**ANSTY GARDEN COMMUNITY,**

**DESIGNERS RESPONSE**

**REPORT REF NO. 2207280-R16**

**Road Safety Audit Stage 1**

Plan attached showing the locations of the problems identified as part of this audit (location numbers refer to paragraph numbers in the report).

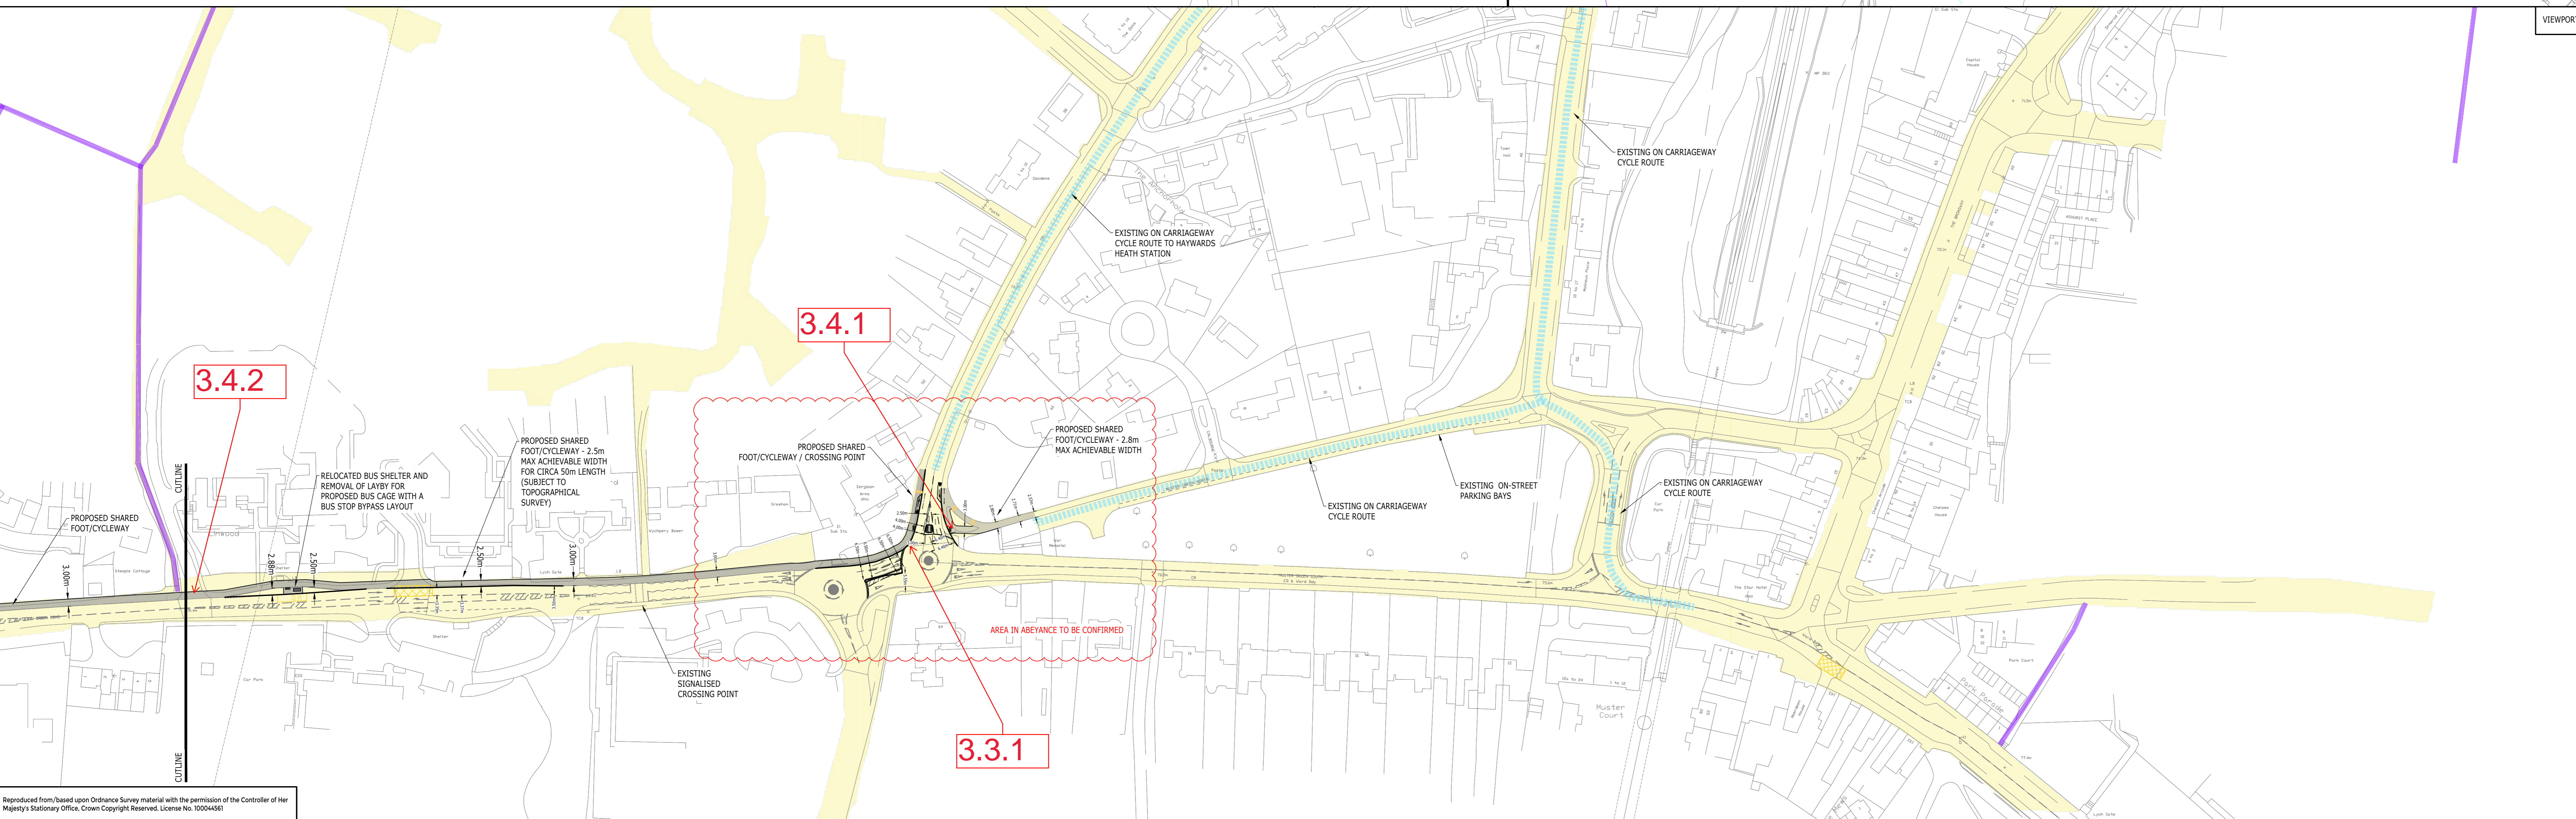
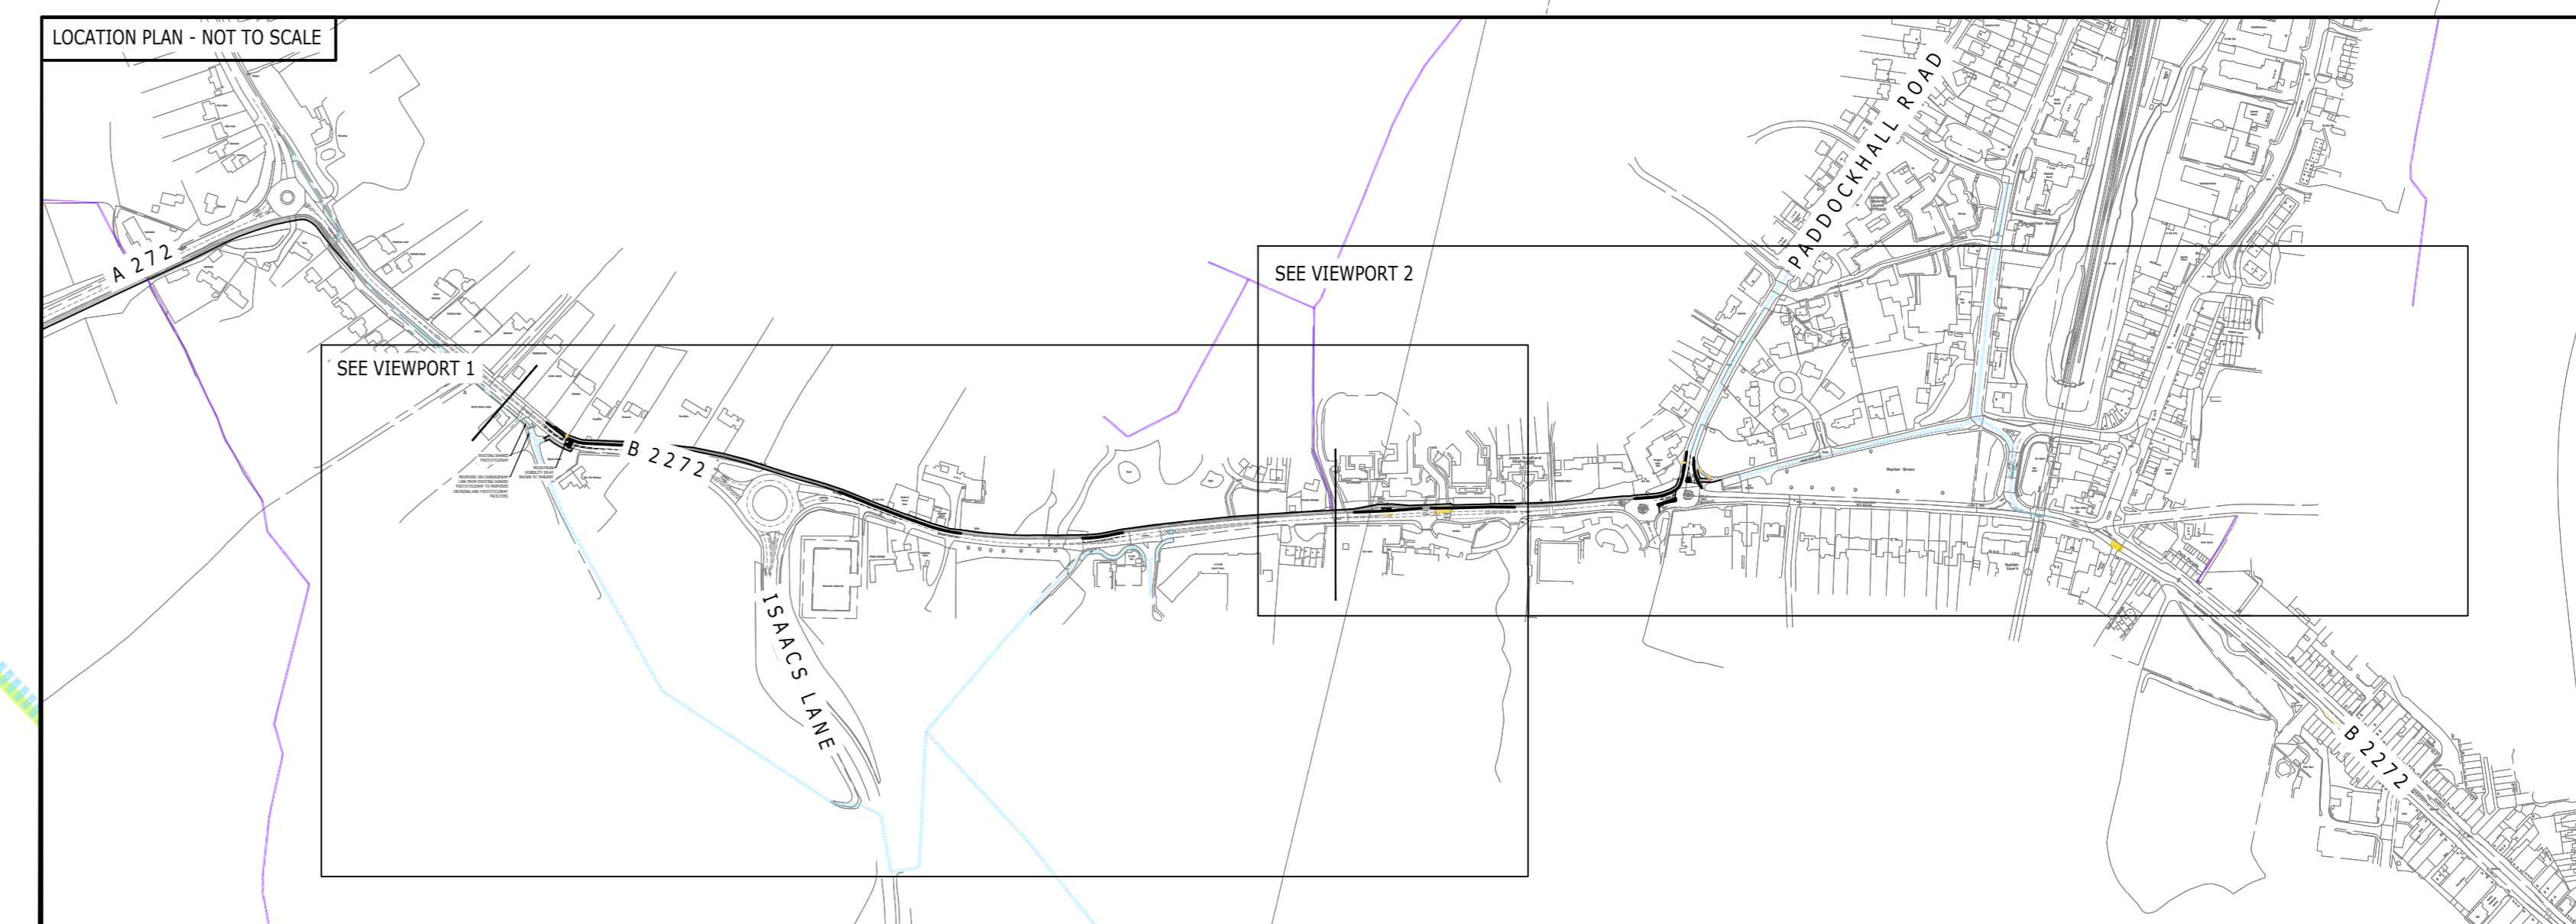
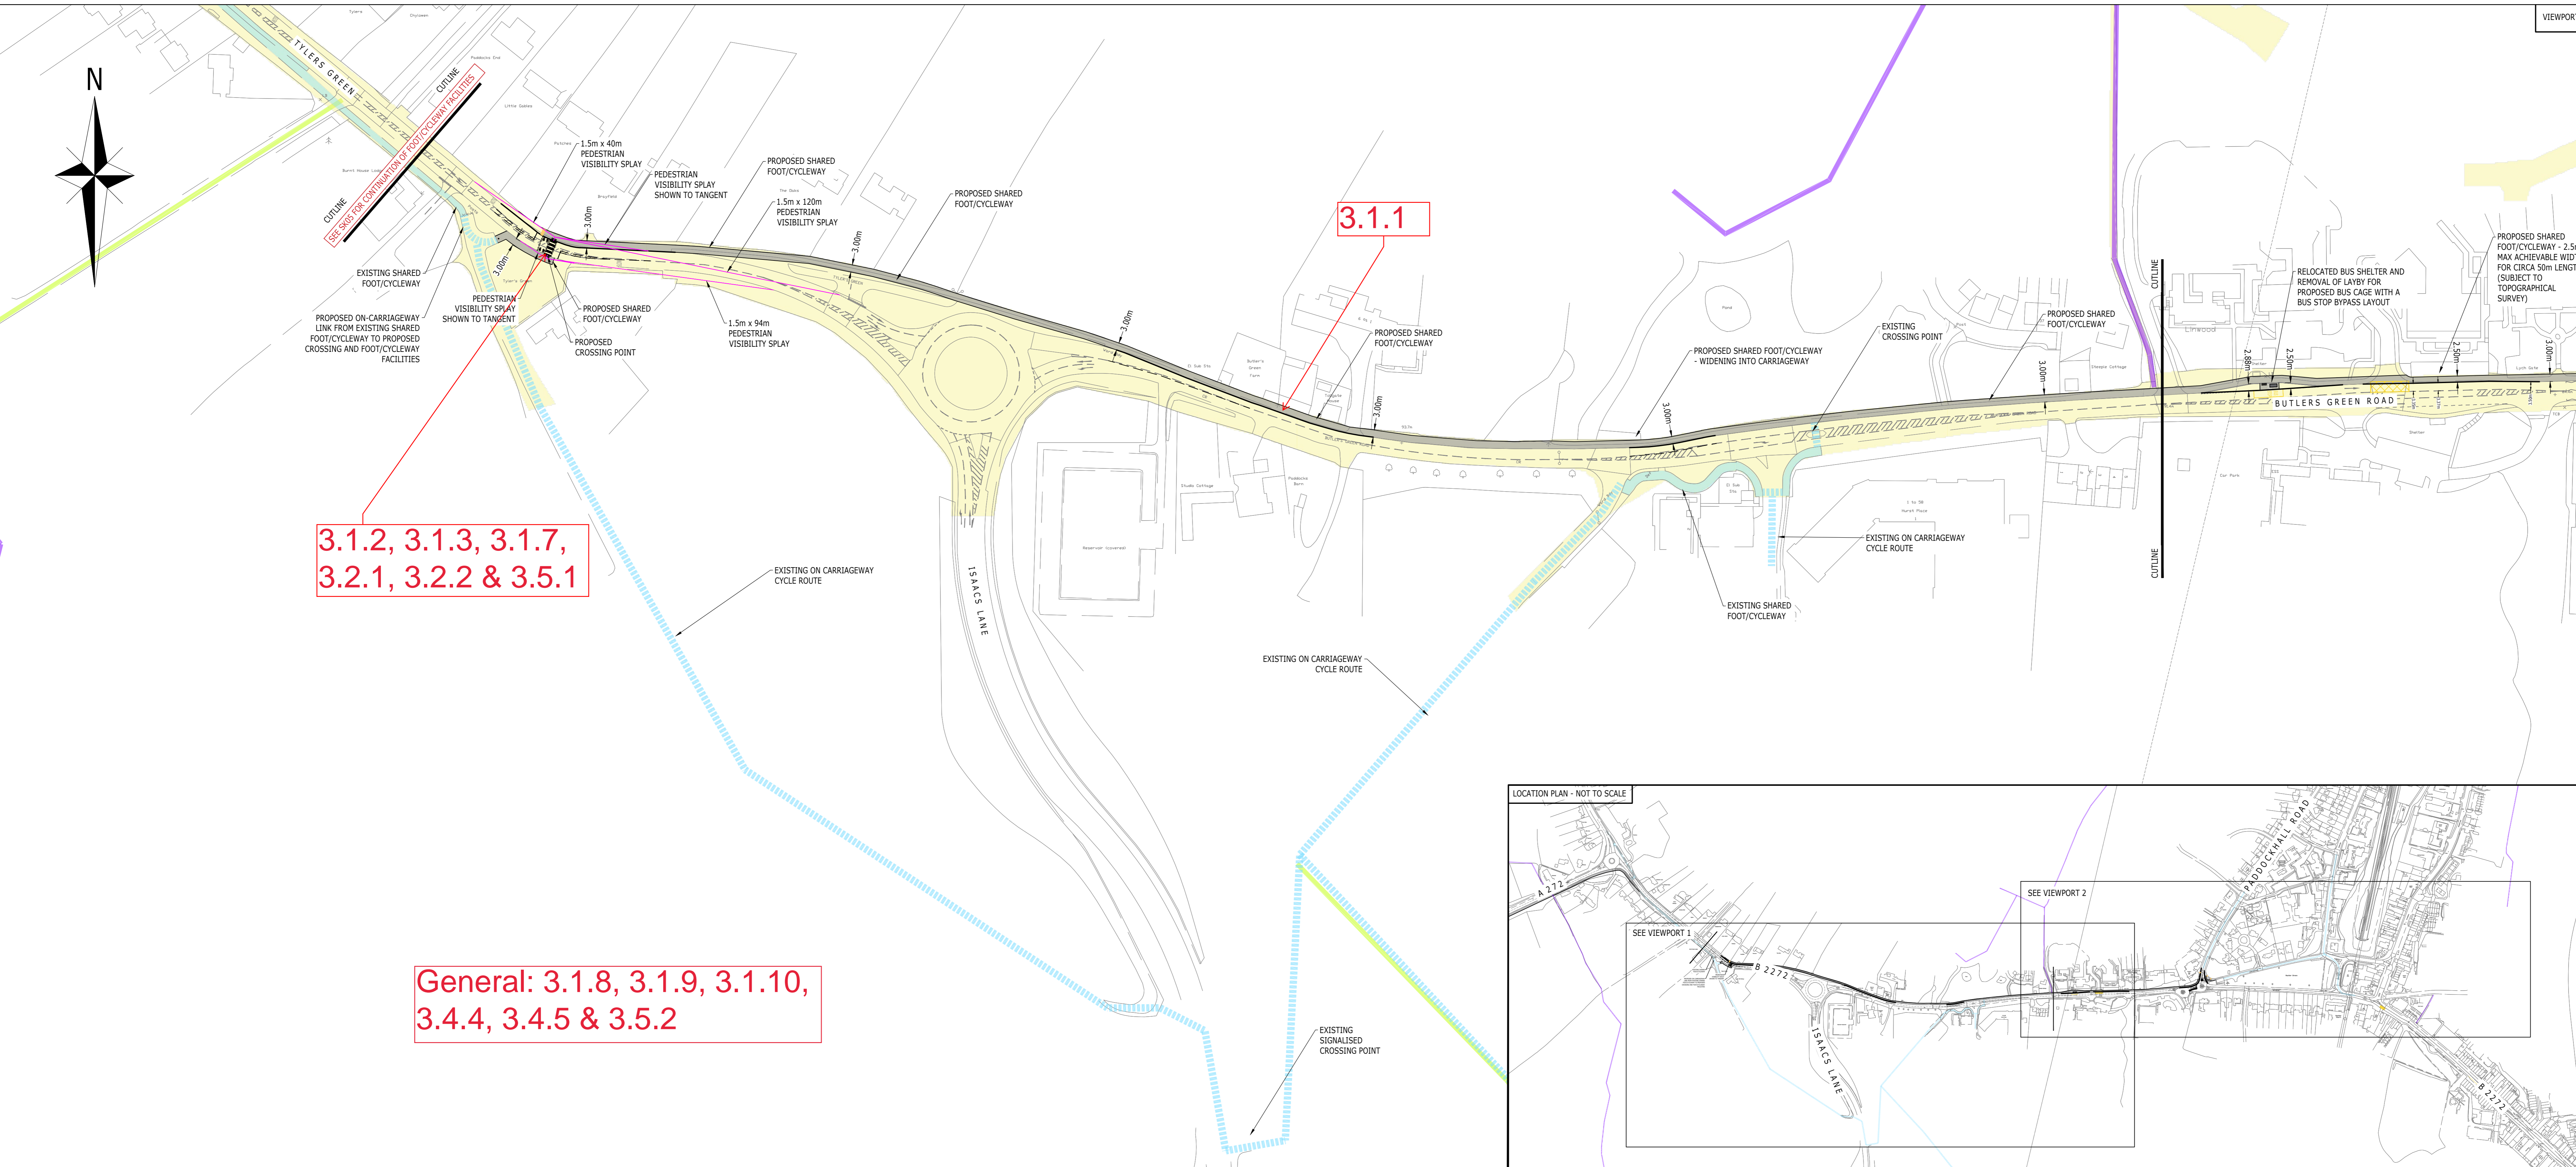
The footway on the northern side of the carriageway is proposed to be a shared use footway / cycleway; however, during the site visit it was noted that there was a significant level difference on the existing footway. Such a level difference could increase the risk of cyclist loss of control collisions, particularly during the hours of darkness.

From observations on site there appears limited demand for this crossing facility. Lack of usage of a controlled crossing can lead to drivers continually seeing no one using the crossing, then being surprised when a pedestrian or cyclist uses the crossing. This could lead to vehicle to pedestrian / cyclist collisions, or sudden braking and rear end shunts.

section of the A272. Parallel crossings should not be installed on roads where the 85<sup>th</sup> percentile speed is above 35mph, as otherwise this may lead to vehicle to pedestrian / cyclists collisions.

To the west of the sewage treatment works on the southern side of the carriageway there is an existing vehicle restraint system (VRS) that lies with the path of the proposed shared use route. Due to the road conditions the Audit Team were unable to determine the terminal type; however, should the VRS have a ramped end P1 terminal, there is concern that if a terminal of this type is reinstated that this could lead to vehicles being launched in the event of a loss of control collision, which could increase severity of the collision. Further, they may be a drop at the rear of the carriageway which may need to be accommodated.

From observations on site there appears limited demand for this crossing facility. Lack of usage of a controlled crossing can lead to drivers continually seeing no one using the crossing, then being surprised when a pedestrian or cyclist uses the crossing. This could lead to vehicle to pedestrian / cyclist collisions, or sudden braking and rear end shunts.

Although on site observed traffic speeds were moderate, no traffic flow, speed data or details of pedestrian movements were supplied for assessment, where a national speed limit applies to the section of the A272. Parallel crossings should not be installed on roads where the 85<sup>th</sup> percentile speed is above 35mph, as otherwise this may lead to vehicle to pedestrian / cyclists collisions.

The proposals do not include the introduction of anti-skid surfacing or a surface with a high polished stone value (PSV) on the approaches to the Parallel crossing. Surfacing with an inadequate PSV could lead to vehicles not being able to stop, leading to possible rear end shunt or vehicle to pedestrian / cyclist collisions.

Stopping Sight Distances (SSD) have been provided for assessment at 40m eastbound and 94m westbound, where a 40mph speed limit applies to this section of 40mph. There is concern that the eastbound 40m SSD may be insufficient. An insufficient SSD may increase the risk of vehicle to pedestrian / cyclist collisions or rear end shunts in the event of sudden braking.

On the westbound approach to the Parallel crossing a 120m SSD has been proposed. Whilst a national speed limit applies, it is likely that traffic will slow down to negotiate the roundabout. However, there is concern that the SSD could pass over non-highway land. Vegetation or trees in this splay could restrict visibility, where restricted visibility may increase the risk of vehicle to pedestrian / cyclist collisions or rear end shunts.

Stopping Sight Distances (SSD) have been provided for assessment, 215m at the national speed limit for the nearside and 120m, equivalent to 40mph to the offside. Whilst the roundabout the roundabout junction will likely lead to speeds less than 60mph, there is concern that a 120m SSD may be insufficient. An insufficient SSD may increase the risk of vehicle to pedestrian / cyclist collisions or rear end shunts in the event of sudden braking.

Kerblines are being amended to accommodate the proposed scheme; however, no swept paths have been provided assessment. There is concern that larger vehicles such a refuse vehicle may not be able to undertake turning manoeuvres without entering the adjacent running lane or opposing carriageway or colliding with street furniture. Insufficient carriageway space could lead to sideswipe collisions, or footway overrun and potential vehicle to pedestrian collisions, or collisions with the pedestrian refuge, and possible loss of control collisions.

Kerblines are being amended to accommodate the proposed scheme; however, no details relating to the pedestrian / cyclist / traffic intervisibility have been provided for assessment. There is concern that the fencing on the eastern side of the carriageway of Paddockhall Road may restrict intervisibility. Restricted intervisibility could lead to vehicle to pedestrian / cyclist collisions.

There is no pedestrian crossing point across the proposed junction mouth, where this is likely to be a pedestrian desire line. This may present difficulties particularly for the blind, and visually and mobility impaired pedestrians, which may lead to pedestrian trips and falls.

Details relating to the pedestrian / traffic intervisibility splays at the crossing have been provided for assessment. However, there is concern that vegetation / hedgerow may restrict intervisibility. Restricted intervisibility could lead to vehicle to pedestrian collisions.
